Town of Parker Community Development Department  
Development Review Division  
Attention: **Stacey Nerger**

Application Type: **Replat**  
Status: **First Referral**  
Application Name: **Parker Auto Plaza F1 AMD 2**  
Case/AP#: **SUB20-025**  
Referral Received: September 25, 2020  
Comments Due: October 23, 2020

Review date: **September 30, 2020**  
Plan reviewer: **Randall L. Capra, [rcapra@parkeronline.org](mailto:rcapra@parkeronline.org)**  
Phone: 303.805.3169

**Lot 1 – Bldg 1 & Lot 1 – Bldg 2:**

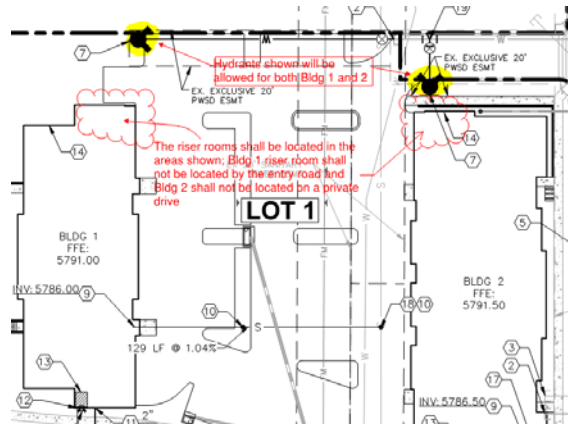
4. The location of the riser room for all three of the four proposed buildings is not acceptable; the applicant was provided with guidelines in as to approved locations in our pre-application meetings and as such, will be required

to revisit the submittal. Bldg 1 riser room location is not acceptable by the main entry and Bldg2 and Bldg 3 are not allowed to have the riser room located on a roadway... even if the access is a private road. Additionally, the applicant will need to identify the location of the fire sprinkler control valve room (more clearly showing its location), provide additional fire hydrants, and ensure the following: *Satisfied; applicant acknowledged/addressed with December 14, 2020 submittal response.*

- Exterior access is required into the riser room with access in the building provided either adjacent to the riser room or through the riser room. Access into the fire riser room shall not be through the volley ball court.
- The FACP will be required to be located in the fire sprinkler control valve room; ensure that the riser room is sized to accommodate the FACP and the riser. **A three-foot clearance is required in front of the FACP as well as the sprinkler riser.**
- The underground shall enter the building and turn up no further than 24 inches from foundation wall.
- The FACP shall be located on an interior wall.

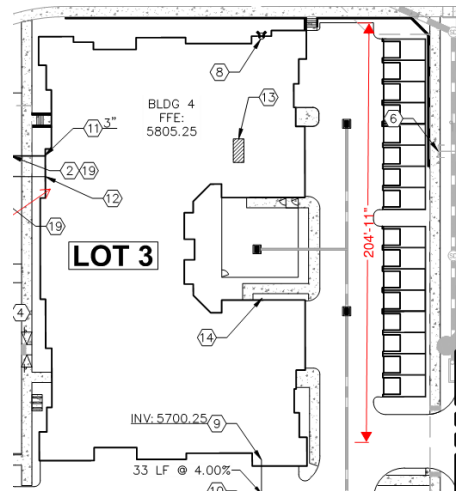
7. The applicant has provided an access road that exceeds 150' on the east side of Lot 3, Bldg 4; this access, as measured from the center line of the access perpendicular to this drive, is approximately 205 feet long. The applicant shall revisit the drive and configure the site to ensure that a dead end is not created that exceeds 150 feet, as required per [18 IFC 503.2.5]. Address this issue when resubmitting. *Satisfied; applicant acknowledged/addressed with December 14, 2020 submittal response.*
